HISTORIC PRESERVATION BOARD

HISTORIC PRESERVATION BOARD MEETING

**PUBLIC HEARING
FIRST PARISH CHURCH, 425 CONGRESS STREET**

TO: Chair Sheridan and Members of the Historic Preservation Board
FROM: Deb Andrews, Historic Preservation Program Manager
DATE: April 29, 2020
RE: May 6, 2020 **PUBLIC HEARING**

2 PROPOSED SW ELEVATION(SIDE)

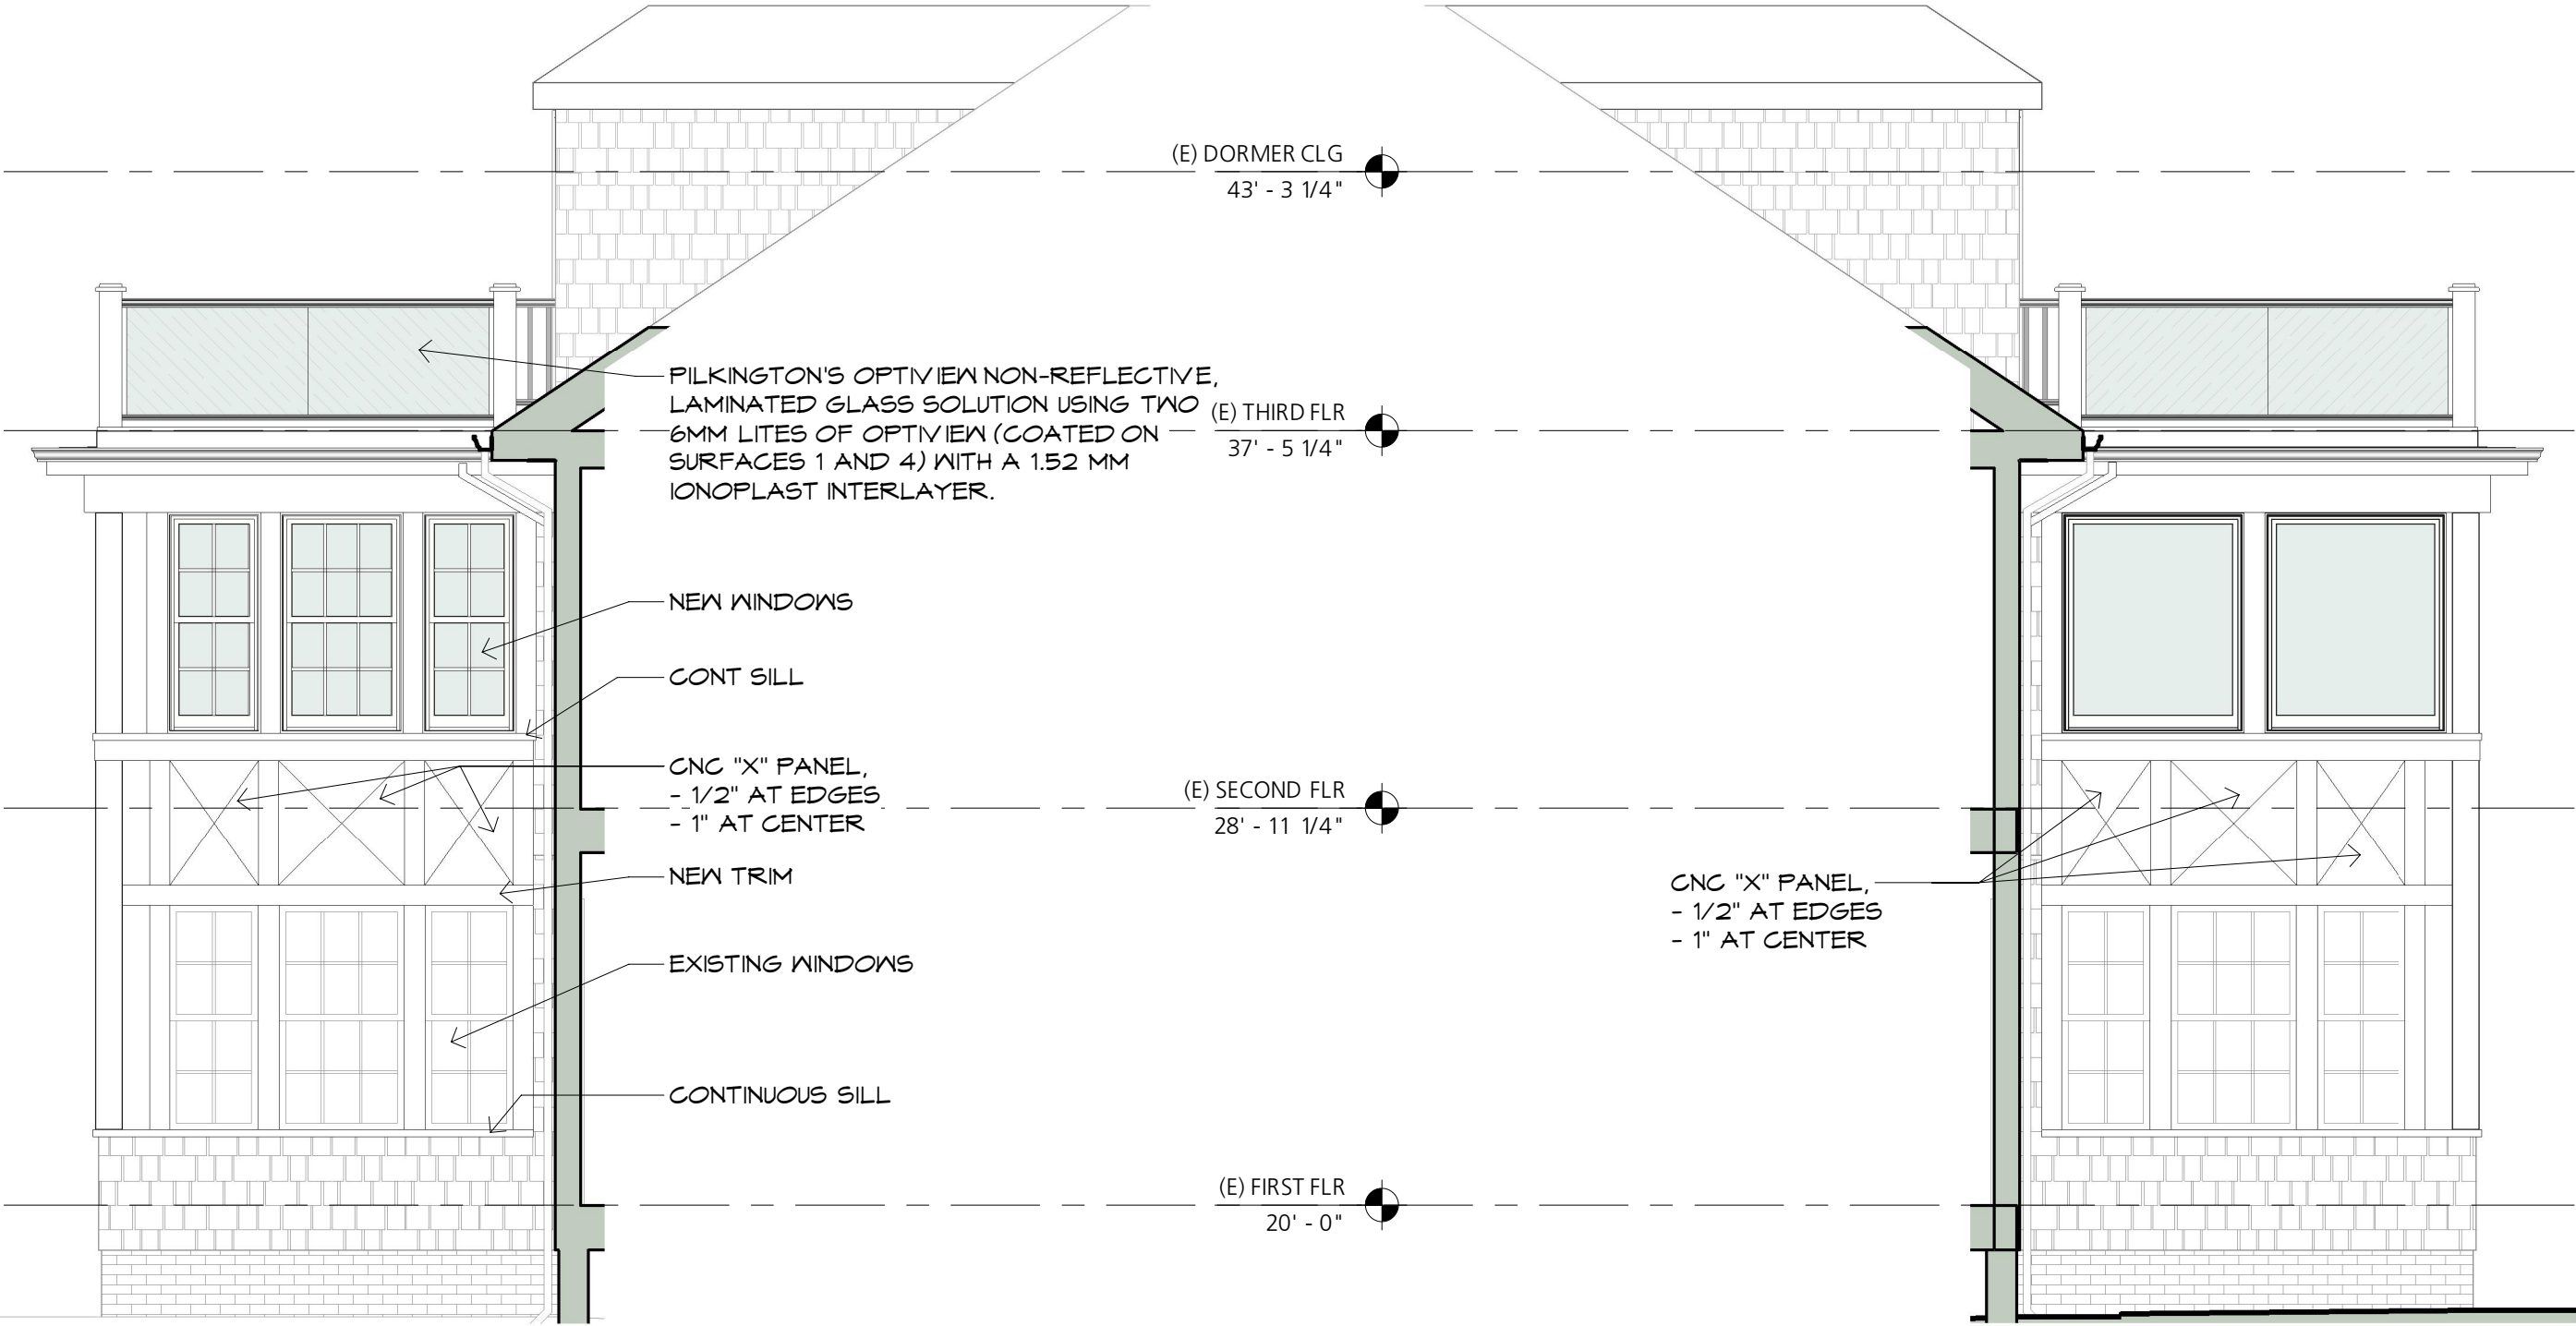
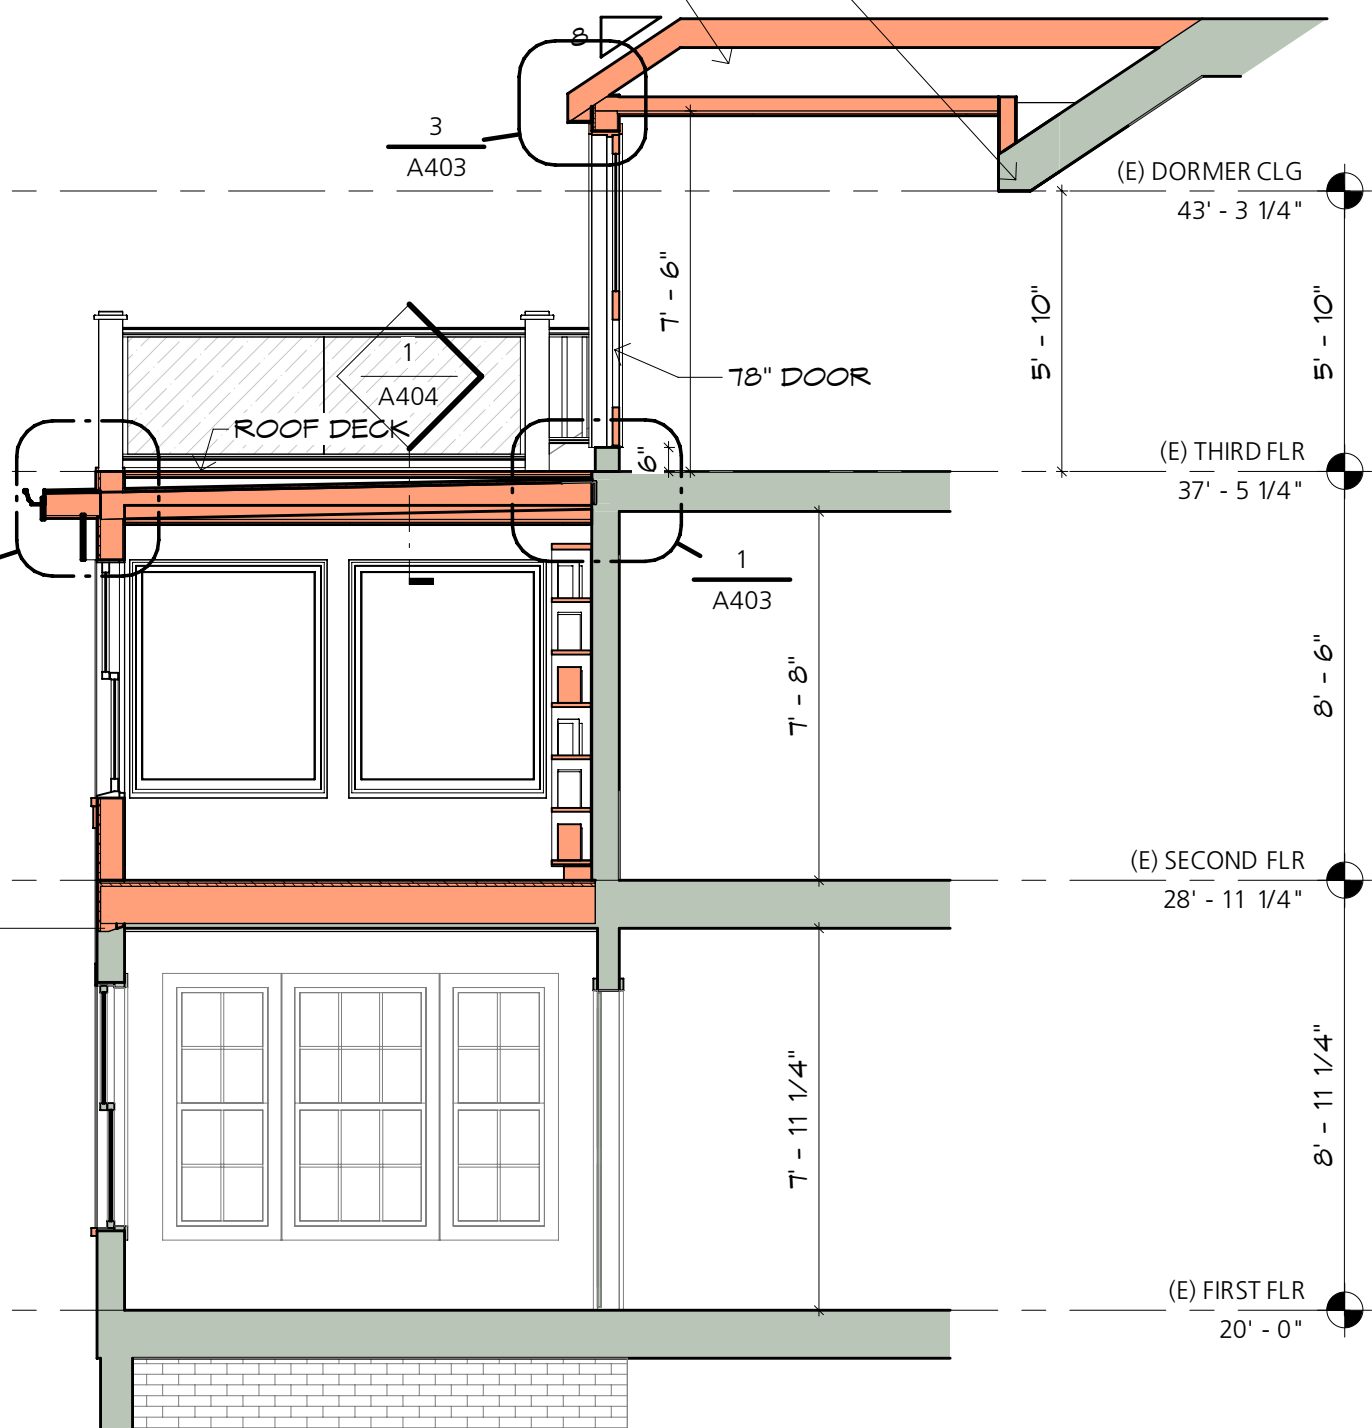
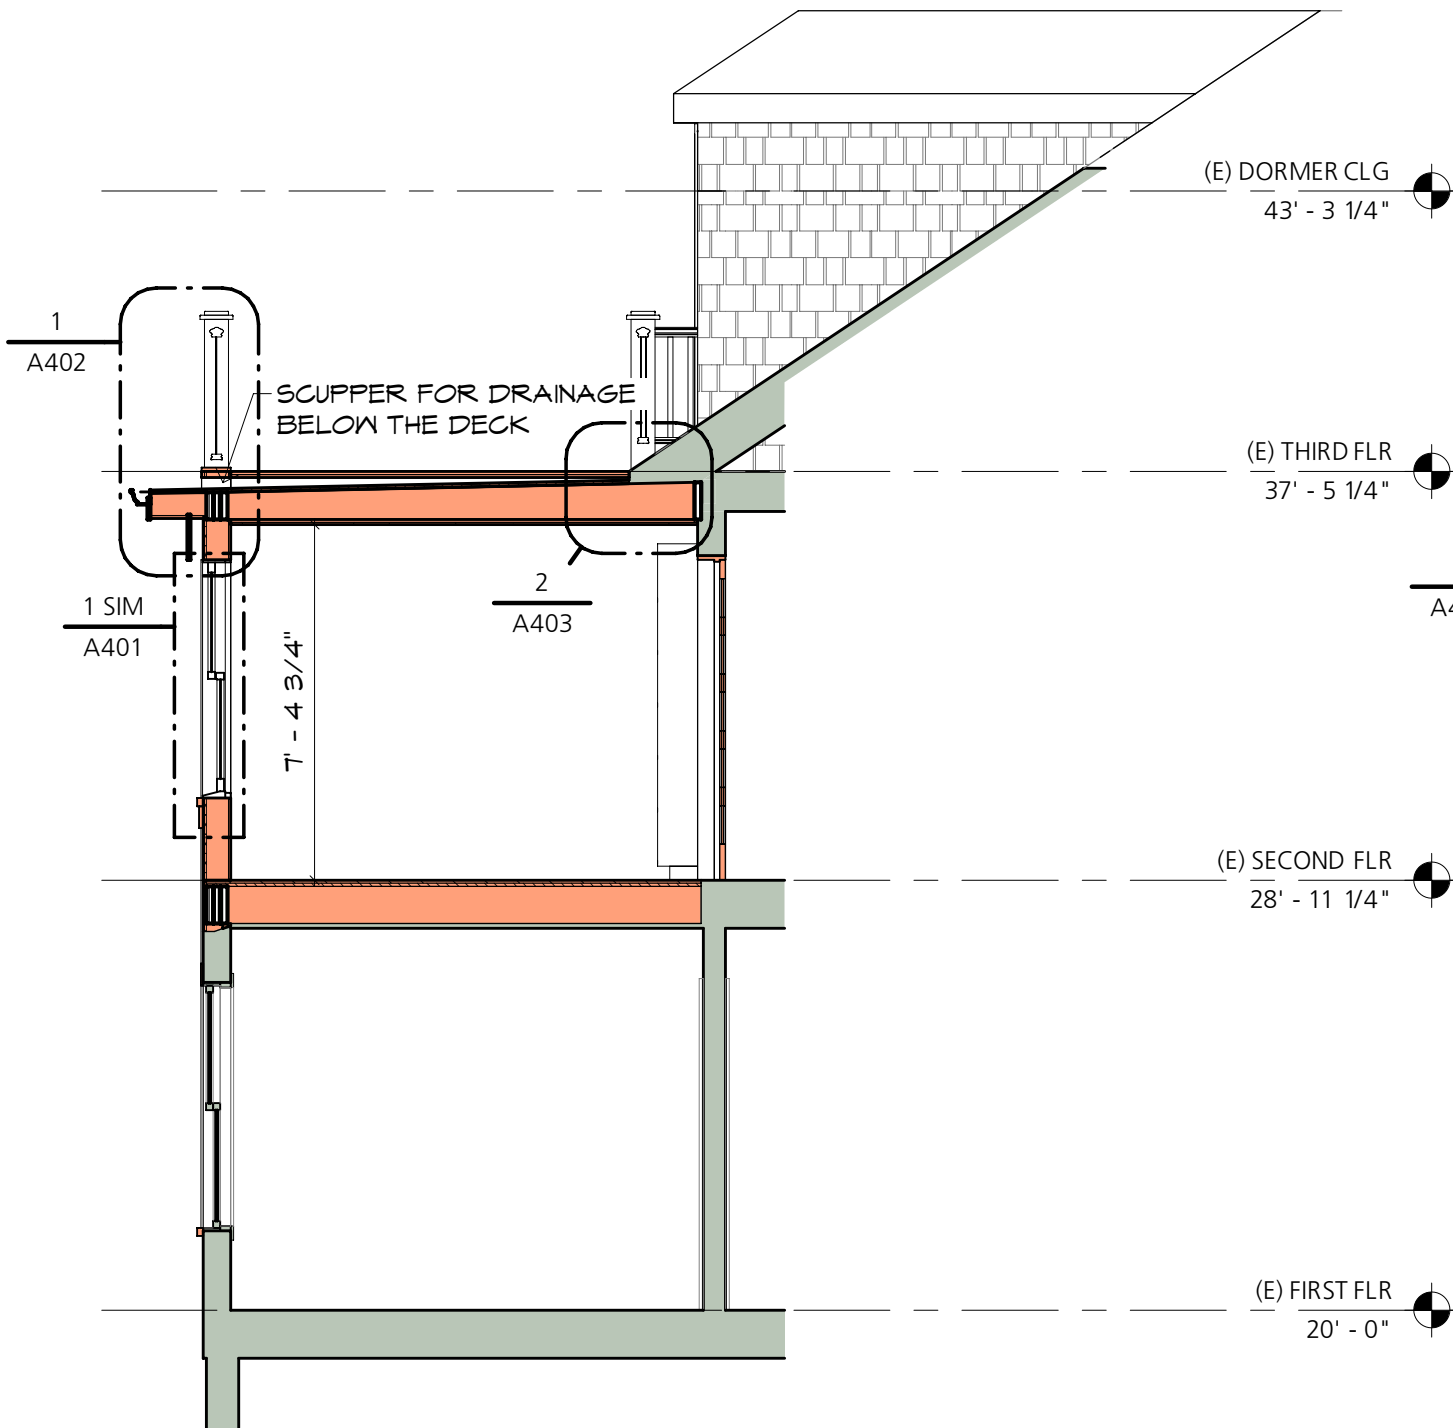
The proposed deck and railing system above the second floor is set back from the edge of the roof such that the posts align with the cornerboards of the sunporch structure. The proposed railing system consists of square posts with simple caps and non-reflective glass panels between posts. The glass panels will be set within a top and bottom rail. A natural finish mahogany top rail is proposed. The elevations show a standard balustered railing adjacent to the roof. Board members should confirm whether this change is intentional or a drafting error.

In this instance, staff is not of the opinion that a clear distinction needs to be made between the architectural treatment of the original sunroom and that of the proposed second-story addition. Here, the decision to provide a consistent architectural treatment throughout appears appropriate. The proposed addition to the sunroom, including the roof deck, and the modifications to the western roof dormer appear compatible with the existing structure and the detailing has been carefully considered throughout. Note, for example, that the deck has been set back from the roof edge in such a way that the corner posts of the railing extend directly above the corner trim boards of the addition.
